DRAFT MOTIVATIONAL REPORT

**PART 2 AMENDMENT: AS PART OF THE PROPOSED LUTZBURG  
SOLAR POWER PLANT NEAR OLIFANTSHOEK IN THE NORTHERN  
CAPE PROVINCE**

**DEA Reference No.** : 14/12/16/3/3/2/938

**Project Title** : The Lutzburg Photovoltaic (PV) Solar Power Project near Postmasburg in the Northern Cape Province

Figure 2.1: Layout plan

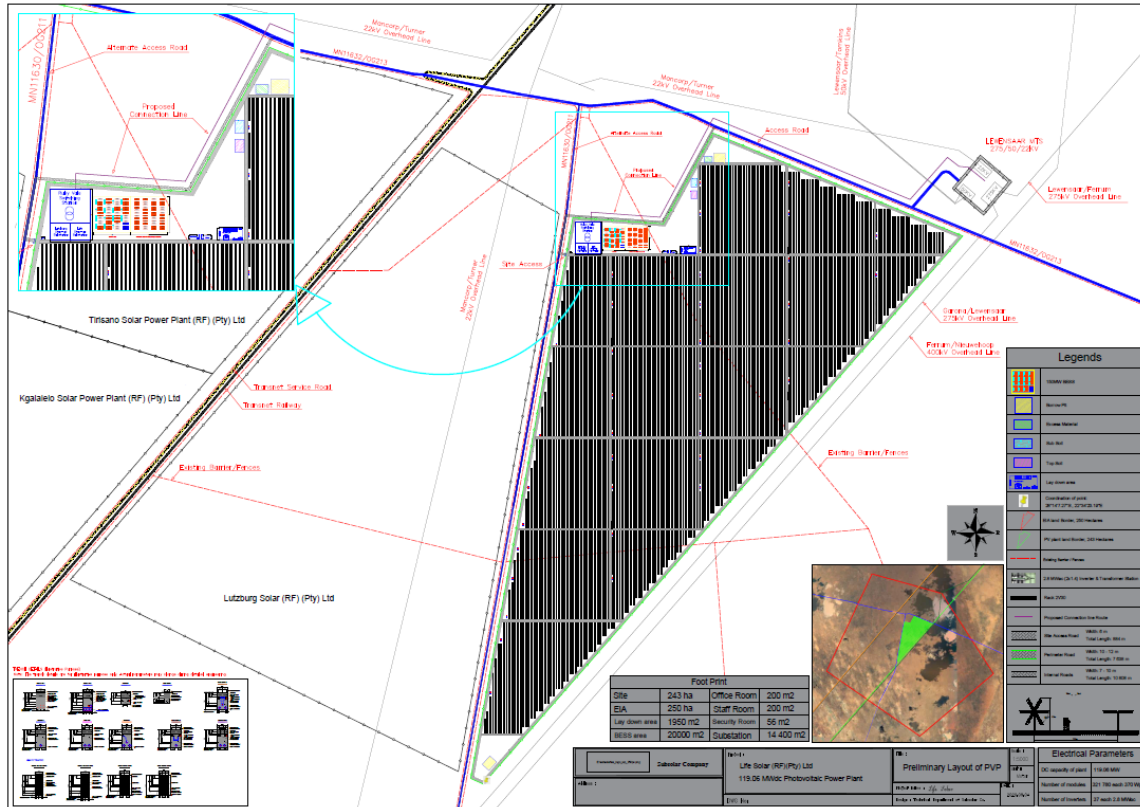
It should be noted that the layout had to be revised as a result of the proposed amendments (refer to Appendix C) but that the final development layout will be determined during the detailed design phase once the project has been awarded preferred bidder status. Table 2.3 below provides detailed information regarding the layout and the components that were authorised.

- Page 7: Section 14- “The development layout plan titled “Lutzburg Solar Power Plant, dated 04 April 2016 is approved” to “The development layout plan titled “Lutzburg Solar Power Plant, dated October 2020 is approved”.

**Figure 3.1:** Proposed amendments

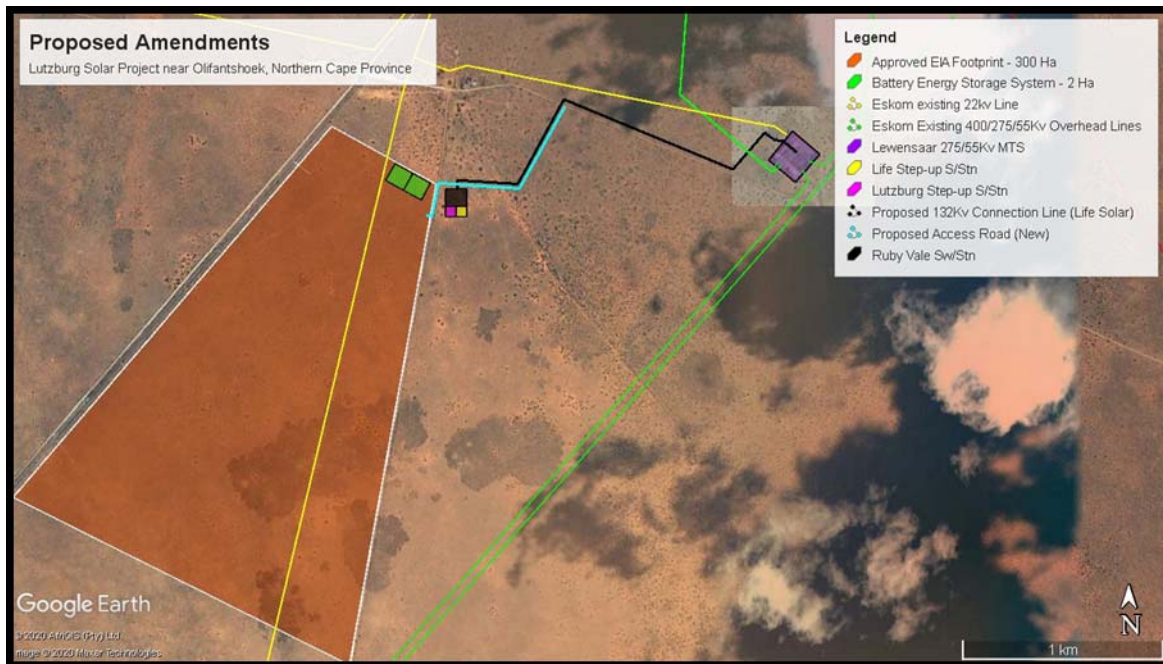
The following amendments are being applied for in terms of the EIA Regulations, 2014 (as amended in 2017)(refer to Figure 3.1):

- Inclusion of a battery storage system

Given the ongoing improvement in battery storage technology and the significant advantages of combining battery storage with renewable generation, it is proposed that battery energy storage systems “BESS” be included for this project in order to meet the requirements to tender the project for the new generation capacity under the Risk Mitigation Independent Power Producer Procurement Program (RMIPPPP) by the Department of Mineral Resources and Energy (DMRE). One of the DMRE’s conditions to tender the project under the RMIPPPP is that all projects must be able to operate between 5h00 and 21h30 in order to supply the grid during peak hours early in the morning and late afternoon when the sun has set, which can only be done by using a battery storage system. The battery storage system will therefore improve the desirability of the proposed project as well as its efficiency.

- Increasing capacity of 115MWdc to up to 150MWdc and the height of the panels

Due to new and advanced technology of panels (470W and Bi-facial) the same amount of panels may be used as specified previously but will be able to generate more megawatts on the same area. The DMRE no longer caps projects at 75MW under the RMIPPPP, which means that developers may tender for larger capacity (if the grid can accommodate it). Using new advanced panel technology will result in the increase in the height of the panels, since the height of the panels will range between 3.5 to 4.5 m.

- Increasing the number of inverters

Due to the increase in MWdc capacity, more inverters are needed to convert the increased DC capacity to AC. The minimum inverters should be amended from 34 to a minimum of 44. Reference should also be made to inverters and not central specifically.

**Figure 3.2:** Proposed Power Line Route

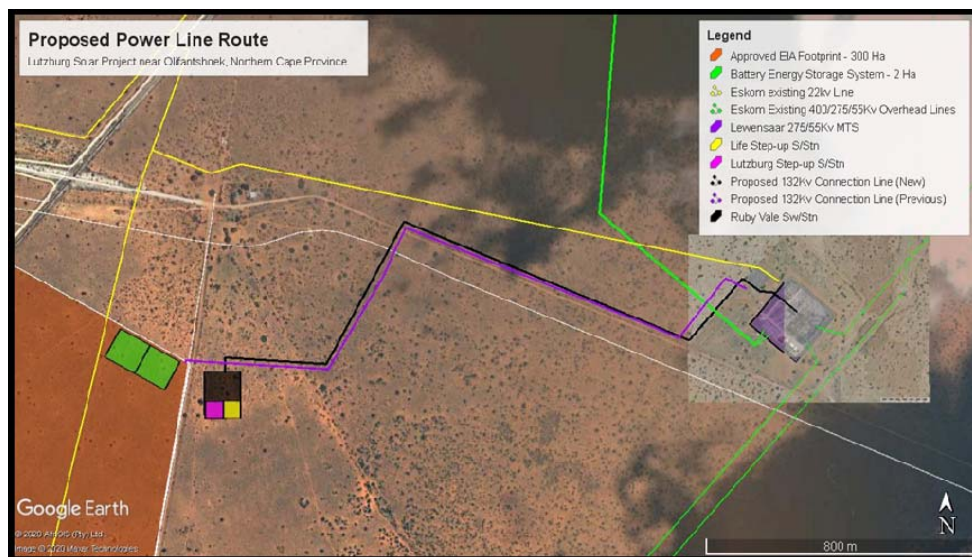
- The location and coordinates of the connection line

After receiving the Cost Estimate Letter for Grid connection and Supply from Eskom, the Proposed Lutzburg Solar Facility cannot connect straight into Lewensaar MTS, it was therefore proposed that the Lutzburg Solar Facility (including other facilities on the property) must first connect to the Ruby Vale Switching station with only one connection line to Lewensaar MTS., the Lutzburg Solar facility will make use of the same connection line as proposed in the Life Solar amendments as the proposed substation is situated on the Life Solar footprint. The proposed new route/corridor has been assessed as part of the Lutzburg, Tirisano and Kgalalelo SPPs.

**Figure 3.3:** Substation and switching station (figure for illustration purposes only)

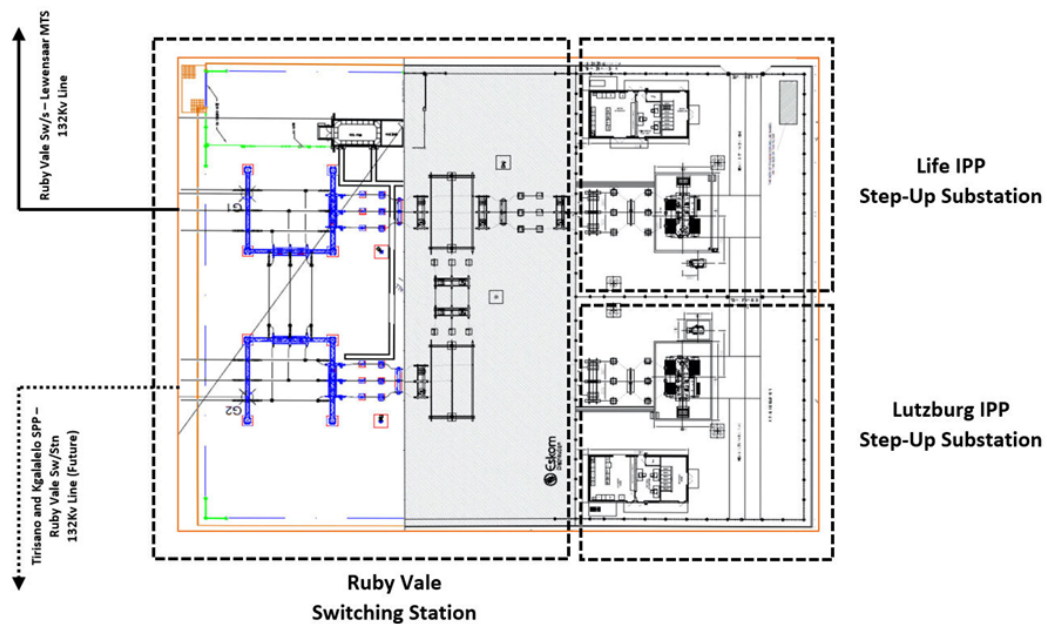
- Increase of Substation footprint and description to accommodate for IPP Step-up Substation and Switching Station

The proposed on site Substation will be situated on the Life Solar footprint and will have a combined footprint of approximately 1.54ha, the substation will consist of two IPP Step-up substations (Life and Lutzburg) and a Switching Station, the Lutzburg step-up substation will step-up the generated capacity to 132Kv in order to connect and supply at the same Voltage at the Lewensaar MTS (after constructing a 132Kv feeder bay), the Switching Station will be the connection between the Step-up Substation and the Lewensaar MTS. The proposed connection line will therefore be constructed using a single line between the Ruby Vale Switching Station and the Lewensaar MTS. The Proposed future Tirisano and Kgalalelo SPP's will also connect with a single line to the Ruby Vale Switching Station.
